UNITED STATES PATENT AND TRADEMARK OFFICE

10/566,218

Office Action Summary	Application No. 10/566,218	Applicant(s) YAMASHITA ET AL.	
	Examiner STEPHEN YANCHUK	Art Unit 1729

DETAILED ACTION

Fig. 3. Synthetic scheme for sulfonated hexafluoro poly(arylene ether nitrile)s

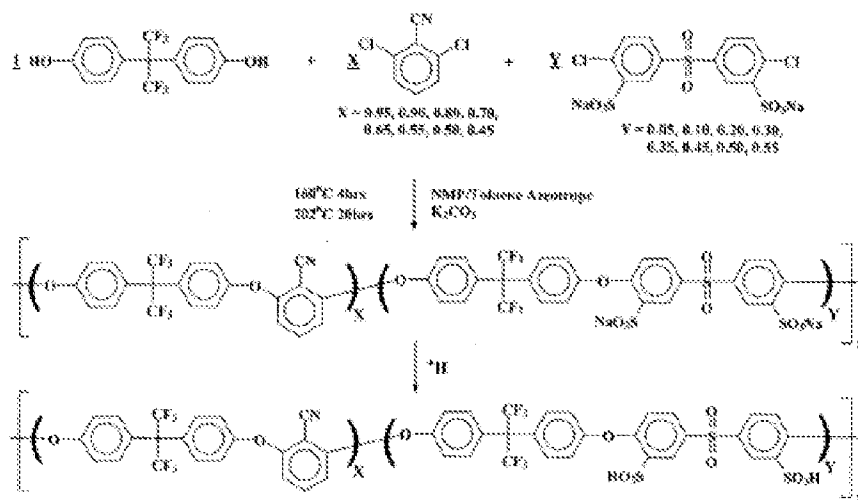
Image from provisional '596 showing proof of invention

Claim 1, 14: McGrath teaches a Polymer electrolyte membrane (PEM) for a fuel cell [Abstract]. The two claimed general formula units of the instant application are taught by McGrath as shown above in Fig 3 of the provisional application. The glass transition temperature is taught to be 200°C [8]. McGrath teaches that the water uptake % is a tailorable variable of the PEM by changing the proportion of the polymers in the layer wherein the ratio of 55:45 produces a max water uptake of about 60% [Fig 3; 61-68]. The calculation provided by the applicant for calculating weight percent is simply the equation for calculating a percent and is therefore inherently taught by the teaching of the maximum water weight retention for the material layer [Fig 3].
